A REVIEW OF THE MILLSTONE-3 PROBABILISTIC SAFETY STUDY

Abel A. Garcia, Principal Investigator

May 30, 1984

Prepared for
Division of Safety Technology
Office of Nuclear Reactor Regulation
U. S. Nuclear Regulatory Commission
Washington, DC 20555

Figure 4.1-2 SEP Experts Sustained Acceleration Results
Based on "Corrected" Dames and Moore Ground Motion Model

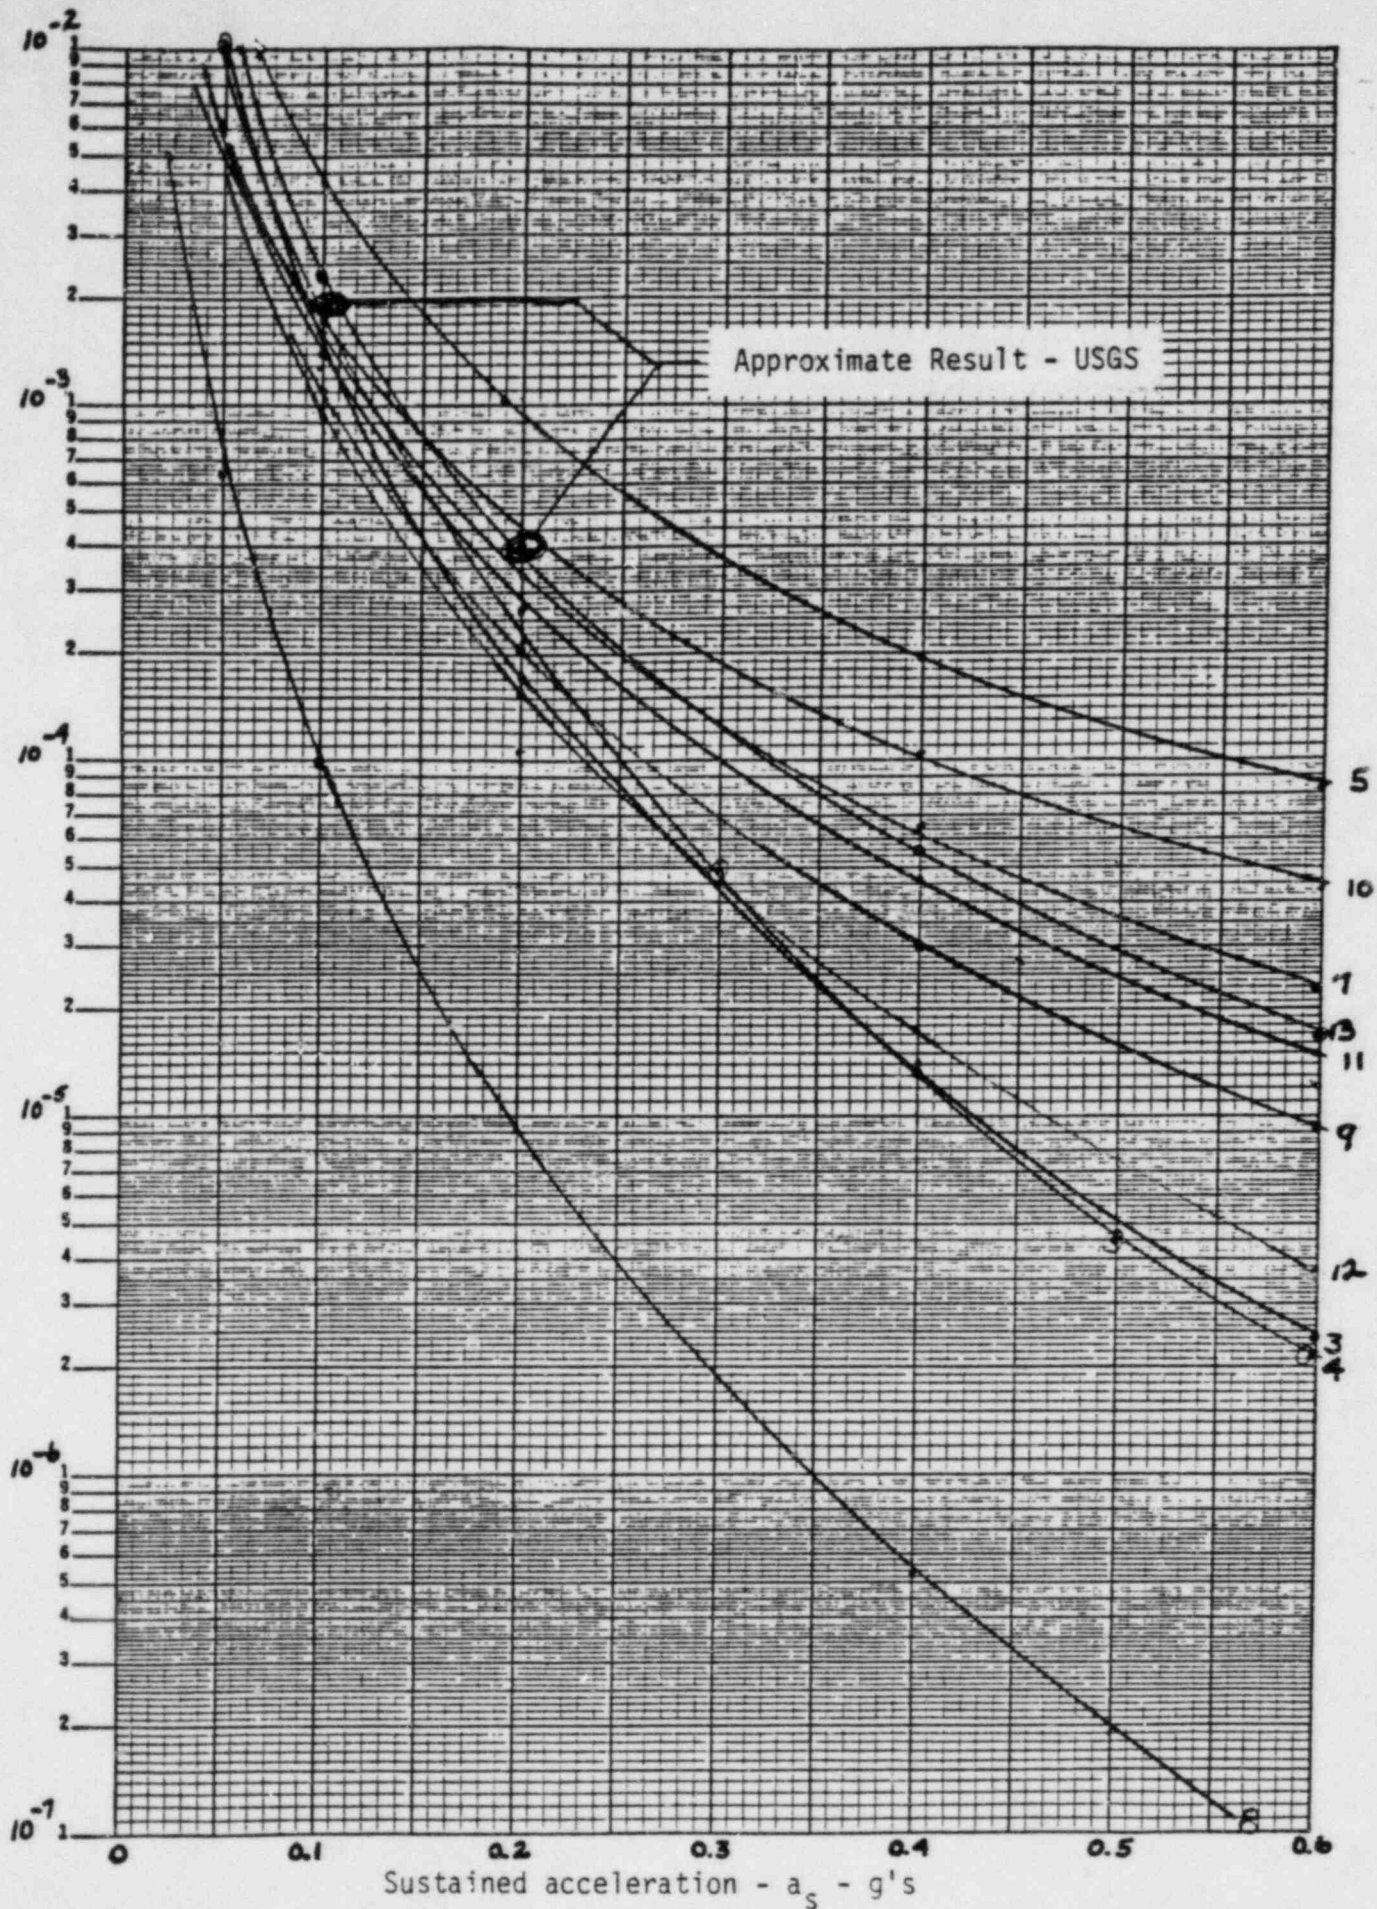
Figure 4.1-2 is a plot of the resulting hazard curves for all the SEP seismicity experts. Figure 4.1-2 also shows two points for approximate "sustained" acceleration estimated from the maps in the USGS report by Algermissen et al. It is seen that the USGS's results are in reasonable agreement with the results obtained using the SEP seismicity experts' models. It must be noted that the USGS study used a significantly different ground motion model. It is difficult to assess exactly what hazard curve would be obtained from the USGS study if the same ground motion model as used in our study was used: It is most likely that the resulting hazard curve would be higher because no random uncertainty was used in the USGS model. In addition, Bernreuter et al. (1984) compares the preliminary results from a new panel of experts to the results obtained for the SEP Study. The agreement between these two studies is excellent.

Figure 4.1-3 Comparison of Hazard Curves Generated by SEP Experts, Dames and Moore, and USGS Approaches

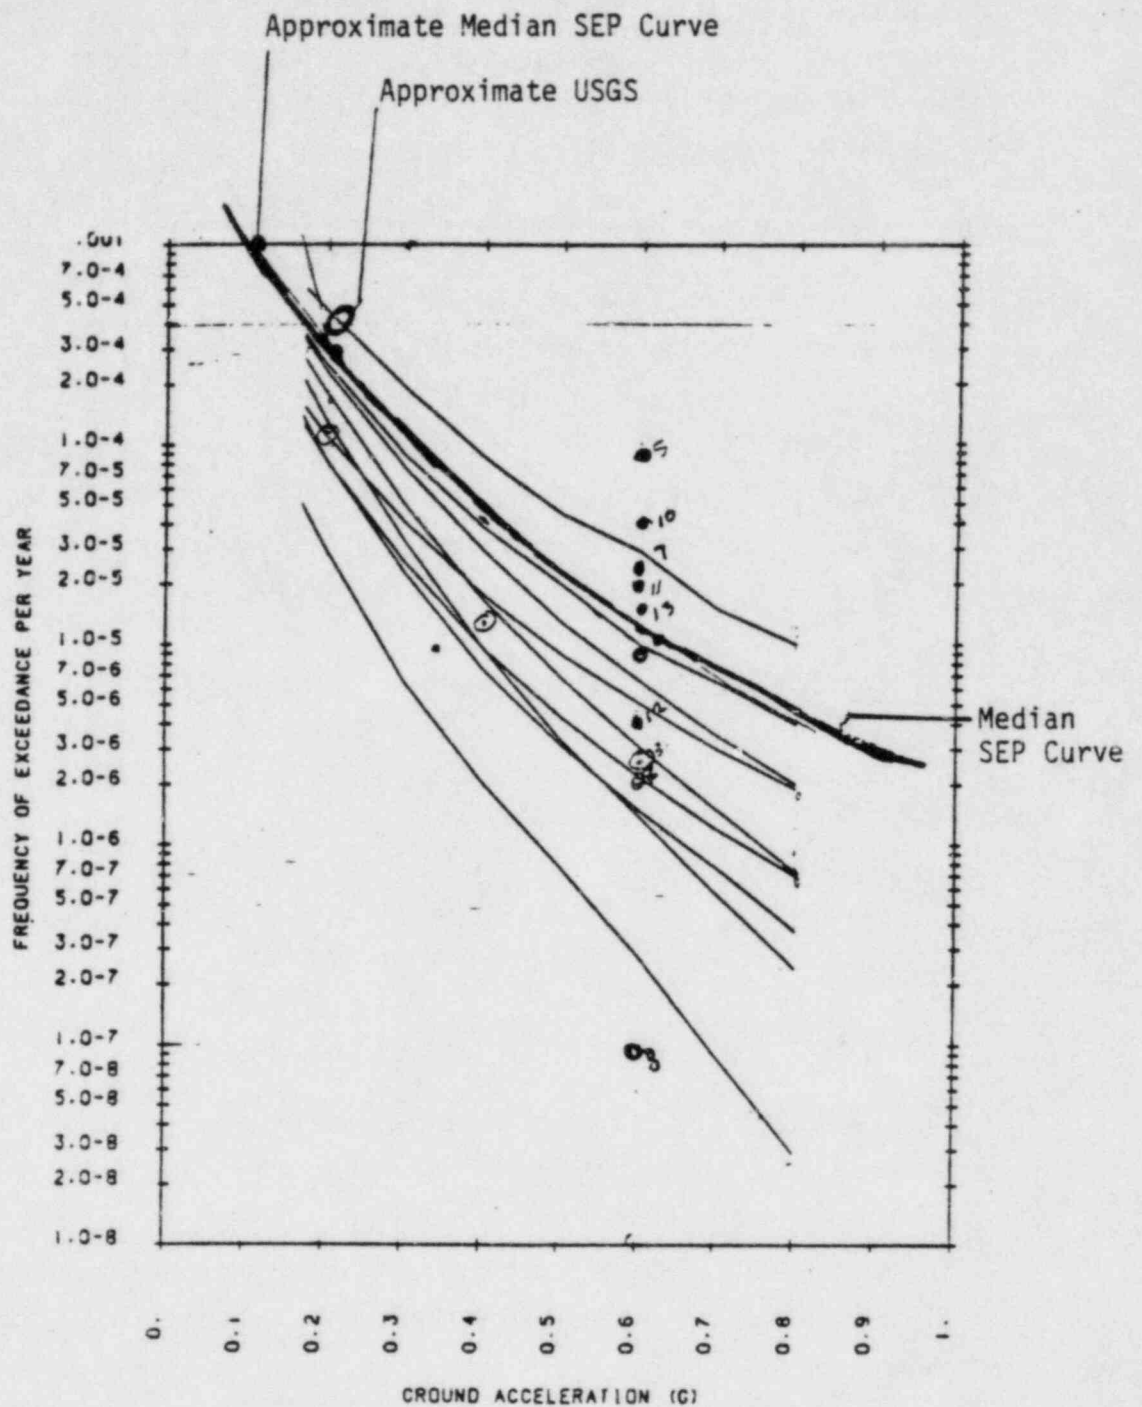
Figure 4.1-3 shows the median curve from Figure 4.1-2 plotted on PSS Figure 1.2.1-1. Also shown is the spread of our curves at 0.6g from Figure 4.1-2. It is seen from this figure that the D&M results are within the spread of the SEP results, but on the low side. It is not possible to determine exactly where the D&M median curve lies relative to the SEP and USGS results because the D&M curves are not equally weighted and the probabilities are not given on the various hazard curves. The D&M median appears to be about a factor of 5 low compared to the SEP median. A reasonably complete uncertainty analysis would spread out the scatter in the curves even more. This increase in uncertainty in the seismic hazard is considered unlikely, however, to have much effect on the median curve, but it could have significant effect on the risk, as it is generally found in such analyses that an increase in uncertainty increases the risk.
